Access Compliance Report

(Curb Ramps)

Intersection ID: 32230	Main Street: DENNINGTON GROVE LN	Cross Street: HEATHERLY CT	Location: NE
ADA ID: 4D23E5752E41	Ramp Type: BlendTrans1	Initial Pass/Fail: Fail	Overall Compliance: No
Severity Score: 8.75			
Codes/Mitigation Info/Possible Solution		Field Measurements/Component Compliance

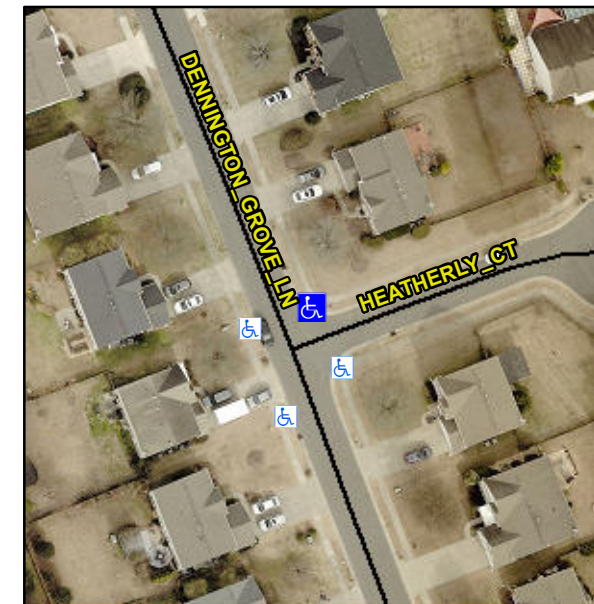
Not Found, R304.5.1

Compliance	Description	Data	Compliance	Description	Data
N/A	Ramp Length (in)	47.0	Yes	BlendTrans Slope (%)	3.0
No	Ramp Width (in)	37.0	Yes	BlendTrans XSlope (%)	1.9
N/A	Flare Type LT	N/A	N/A	Flare Type RT	N/A
N/A	Flare Slope LT (%)	N/A	N/A	Flare Slope RT (%)	N/A
N/A	Flare Traversable LT?	N/A	N/A	Flare Traversable RT?	N/A
N/A	Landing Length (in)	N/A	N/A	DWS Provided?	N/A
N/A	Landing Width (in)	N/A	N/A	DWS Contrast?	N/A
N/A	Landing Slope (%)	N/A	N/A	DWS Length (in)	N/A
N/A	Landing X Slope (%)	N/A	N/A	DWS Full Width?	N/A
N/A	Landing Curb? (Y/N)	N/A	N/A	DWS Offset (in)	N/A
N/A	Shared Landing?	N/A			
N/A	Gutter Ponding?	N/A	N/A	Gutter Slope (%)	N/A
N/A	Gutter Lip Ht (in)	N/A	N/A	Gutter X Slope (%)	N/A
N/A	Painted X Walk1?	No	N/A	Painted X Walk2?	No
	X Walk 1 Direction	To SW		X Walk 2 Direction	To SE
	X Walk 1 Width (in)	N/A		X Walk 2 Width (in)	N/A
	X Walk 1 Slope (%)	2.4		X Walk 2 Slope (%)	1.9
	X Walk 1 X Slope (%)	0.9		X Walk 2 X Slope (%)	0.6

N/A	Ramp inside XWalk1?	N/A	N/A	Ramp inside XWalk2?	N/A
	Road Slope (%)	2.5		Clear Space?	N/A
	Road X Slope (%)	1.3	N/A	Clear Space to XWalk (in)	N/A
N/A	Any Obstructions?	N/A	N/A	Storm Grate/Utility Hazard?	N/A
	Obstruction Type			Storm Grate/Utility Type	
		N/A			N/A
			Yes	Surface Condition? (G/P)	Good
			No	Curb Slope (%)	16.3

Remove & Replace Curb Ramp With Two New Directional Ramps or Equivalent.
